Addendum 25 – UN Regulation No. 26

Revision 1 - Amendment 3

04 series of amendments – Date of entry into force: 25 September 2020

Uniform provisions concerning the approval of vehicles with regard to their external projections

Figure 0
Example of parts distribution

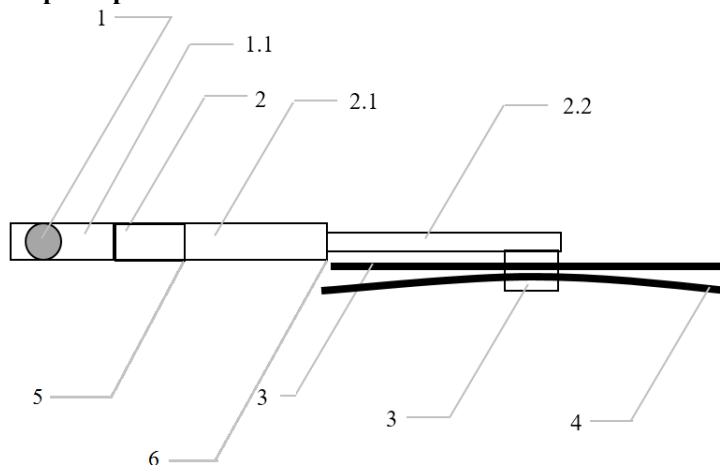
Paragraphs 6.4. to 6.4.2., amend to read:

- "6.4. Windscreen wipers
- 6.4.1. The windscreen wiper fittings shall be such that the wiper shaft (number 1 in Figure 0) is furnished with a protective casing (number 1.1 in Figure 0) which has a radius of curvature meeting the requirements of paragraph 5.4. above and an end surface area of not less than 150 mm². The holder (head and main part, i.e. numbers 2, 2.1 in Figure 0) are designed with a radius of curvature meeting the requirements of paragraph 5.4. above. In the case of rounded covers, these shall have a minimum projected area of 150 mm² when measured not more than 6.5 mm from the point projecting furthest. These requirements shall also be met by rear window wipers and headlamp wipers.

- 6.4.2. Paragraph 5.4. shall not apply to the wiper blades (number 4 in Figure 0), supporting members (number 3 in Figure 0) if present, to second holder (number 2.2 in Figure 0) if present, to the functional hinge between the holder head and the holder (number 5 in Figure 0) if present, or to the junction between the main and the second holder (number 6 in Figure 0) if present. However, these units shall be so made as to have no sharp angles or pointed or cutting parts.

Model A

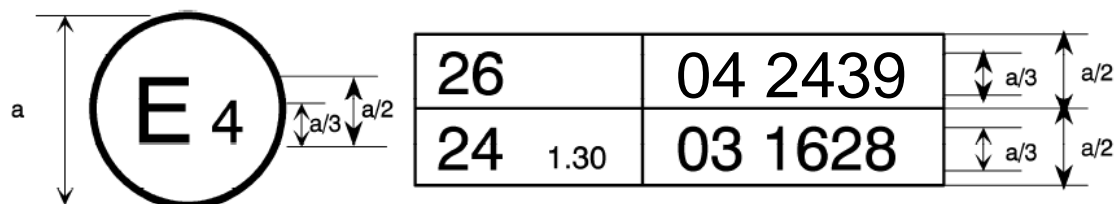
Annex 2, amend to read

The above approval mark affixed to a vehicle shows that the vehicle type concerned has been approved in the Netherlands (E 4) pursuant to UN Regulation No. 26 and under approval number 032439. The first two digits of the approval number indicate that UN Regulation No. 26 already included the 04 series of amendments when the approval was granted.
